CERTIFICATE OF THE SECRETARY OF ENERGY AND ENVIRONMENTAL AFFAIRS
ON THE
ENVIRONMENTAL NOTIFICATION FORM

PROJECT NAME : Alewife Park
PROJECT MUNICIPALITY : Cambridge
PROJECT WATERSHED : Mystic River
EEA NUMBER : 16473
PROJECT PROPONENT : QHQ-Alewife LLC
DATE NOTICED IN MONITOR : November 10, 2021

Figure 1.7
Commitment Areas

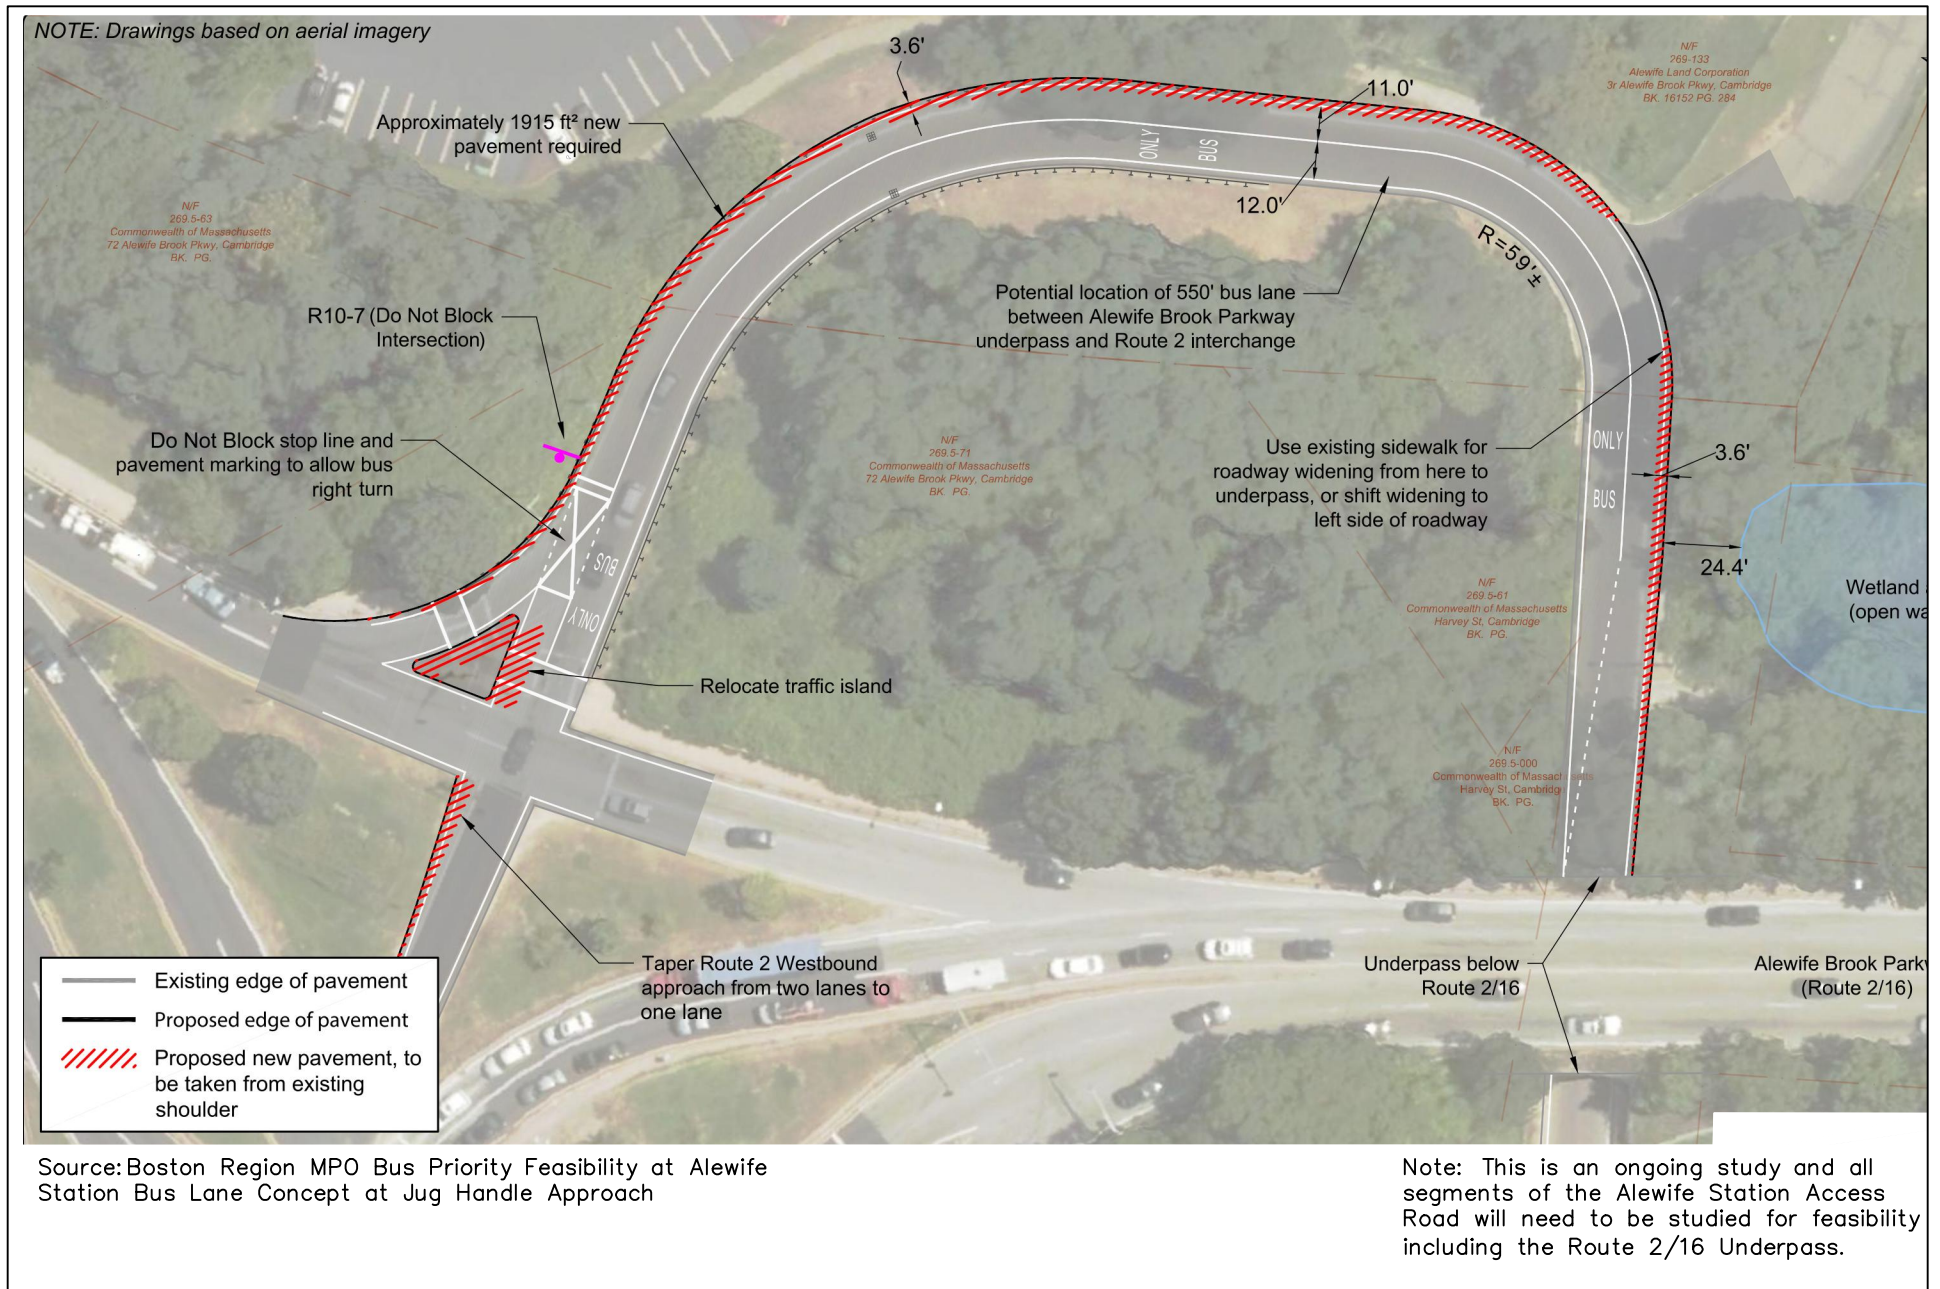
- We recommend the removal of one proposed access point between the MBTA headhouse and the path 'rotary' intersection to reduce the overall impervious area adjacent to the pond and still allow for plenty of pond access opportunities. Please see blue oval on the image on the following page to indicate the suggested removed connection. (Figure 1.7 – Commitment Areas" from ENF.)

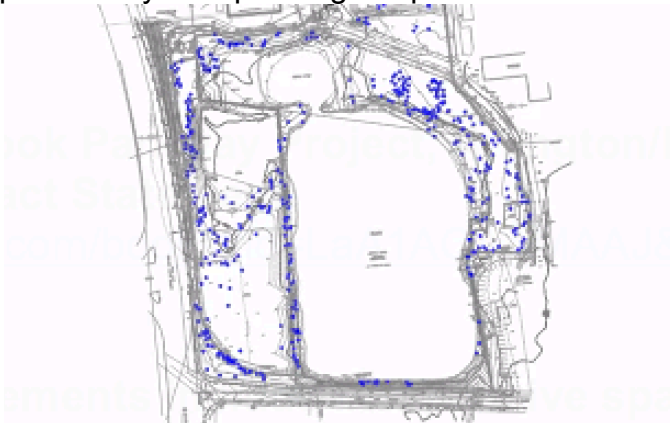
1. Aerial of the site from 1978 showing that the areas around the pond were largely paved. The diamond shaped building on the southwest corner is a fast food restaurant. The larger building to the north of the restaurant is a metal fabrication facility.
